# ERL and Termination effect on COM

(in support of r02-30)

<i>Cl</i> 136	<i>SC</i> 136.11.8	<i>P</i> 233	<i>L</i> 7	#	r02-30
Ran, Adee		Intel Corporation			
<i>Comment Type</i>	<b>TR</b>	<i>Comment Status</i>	<b>X</b>		
<p>The COM parameters for clause 136 correspond to very well-matched channel terminations. The device single-ended termination resistance is 50 Ohm, the package model characteristic impedance is 95 Ohm, and the host board impedance (136.11.8.1) is 100 Ohm.</p> <p>This creates a smooth channel with no reflections outside of the cable, except for the package capacitors (which are within the DFE reach).</p> <p>In reality things will not be so nice. Actual devices and NICs will have reflections outside of the DFE reach (limited by ERL, not not zero). These reflections are not accounted for in the COM budget - leaving a deficit.</p> <p>The effect of far-end reflections is not accounted for in the receiver interference tolerance test COM calibration. So receivers may perform well in the test but fail in real life scenarios.</p> <p>I am planning a presentation with more details of the problem and proposed solutions.</p> <p><i>SuggestedRemedy</i> Upcoming presentation.</p

# ISI from a mismatched host board - visualized

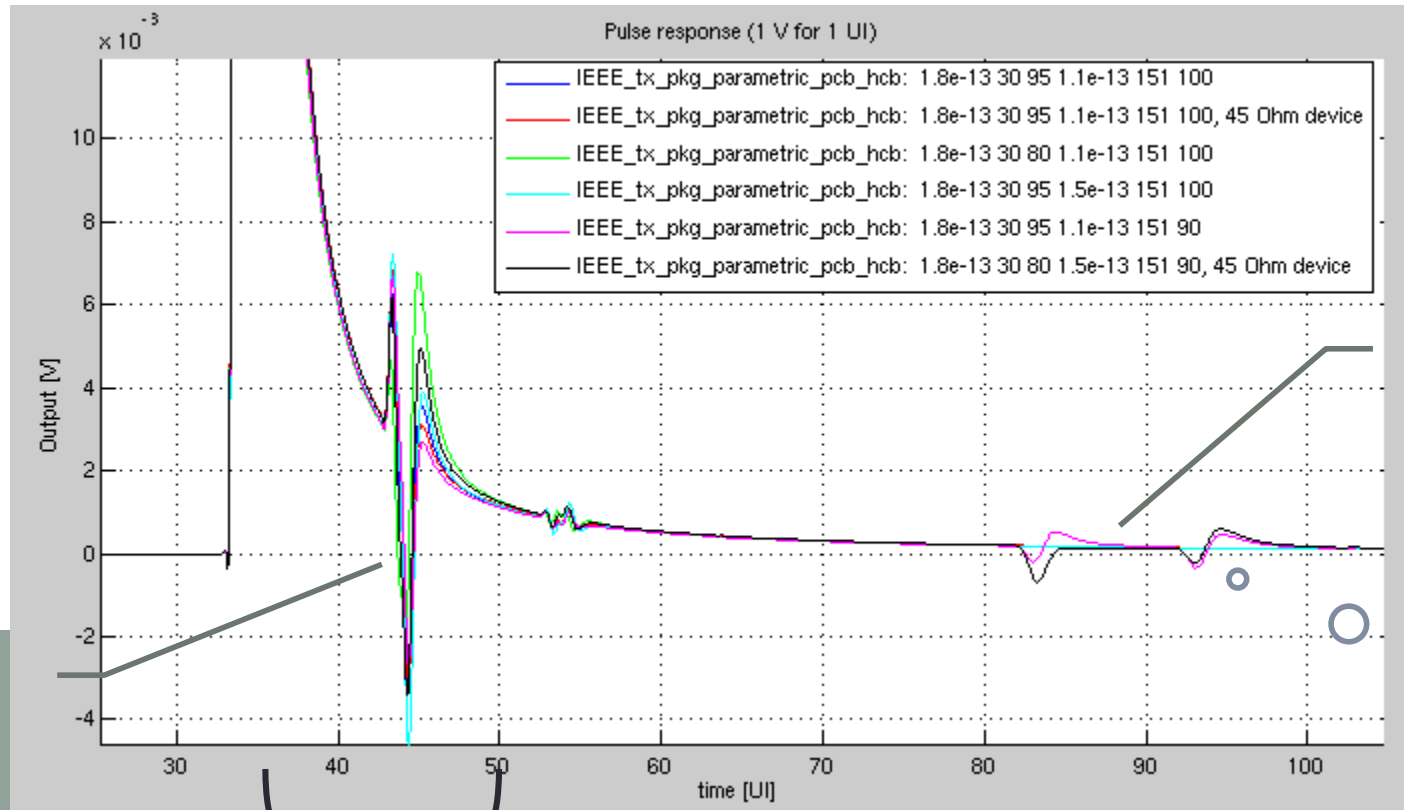
Reflections from package discontinuity – magnitude depends on package impedance and  $C_p$ .

These are within the DFE reach!

Secondary reflections appear when the board impedance is  $90 \Omega$  – not matched to the cable assembly. These are outside of the DFE reach.

Does ERL catch this?

# ERL measurement of host

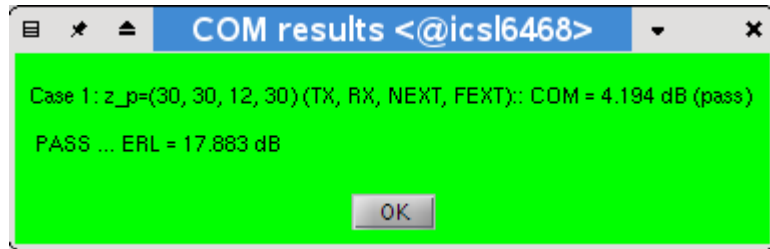
Any reflection from the host board appears in TDR right after the “test fixture delay” so within the DFE reach – therefore it is discounted

Cable assembly measurement has a similar problem  
– impedance mismatch is not counted

# Actual COM test with a cable assembly

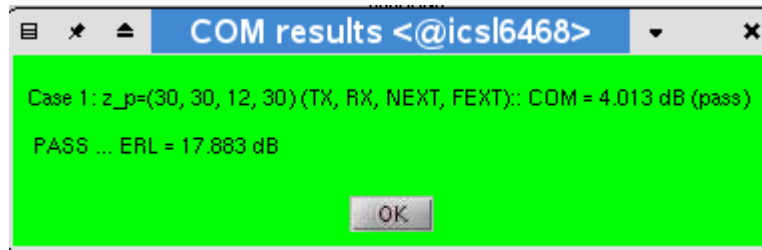
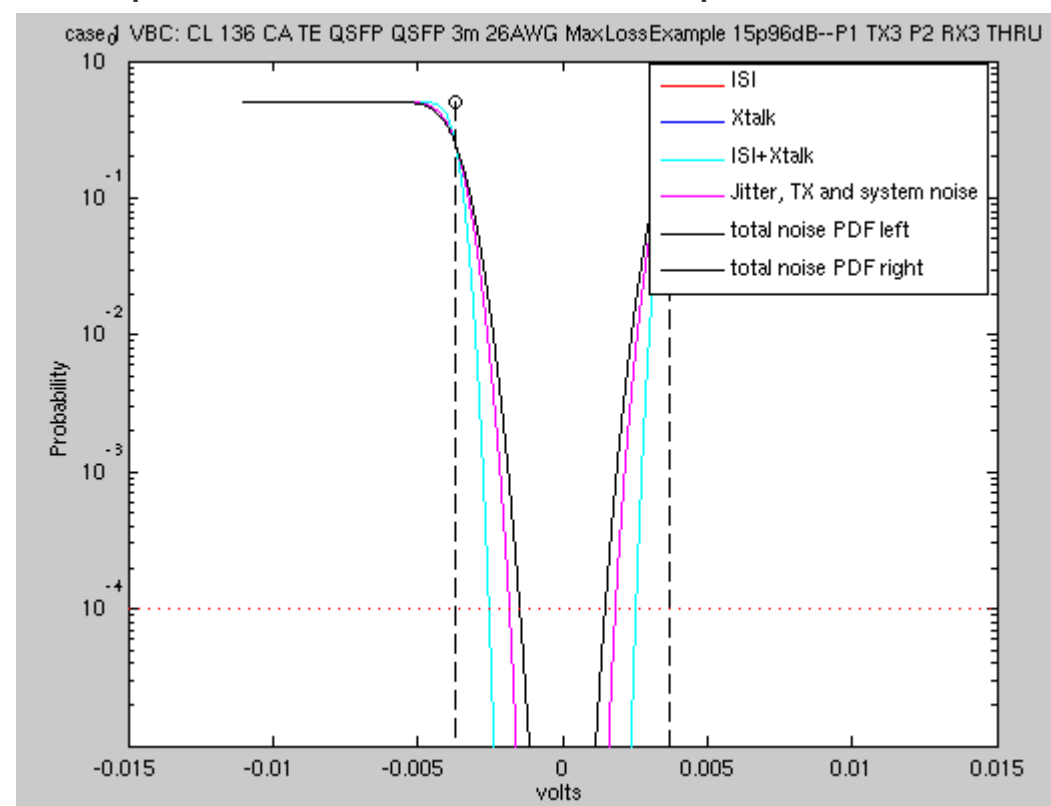
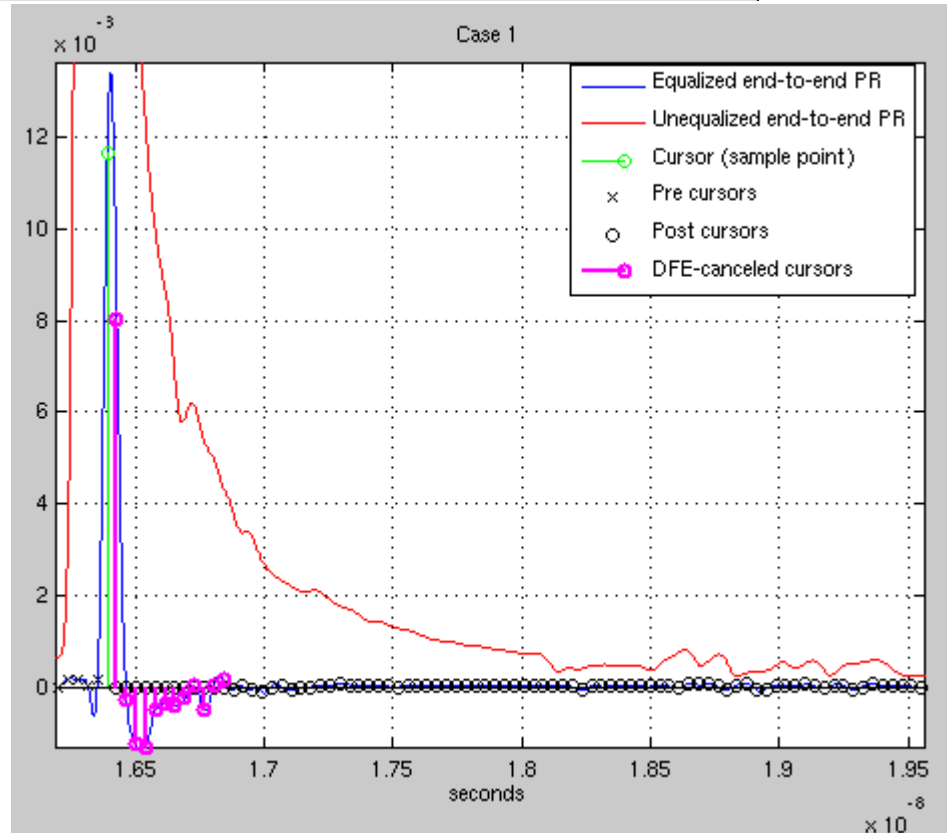
TE\_QSFP\_QSFP\_3m\_26AWG\_MaxLossExample\_15p96dB  
 Thru only  
 Modified parameters as in the example - ~0.18 dB loss
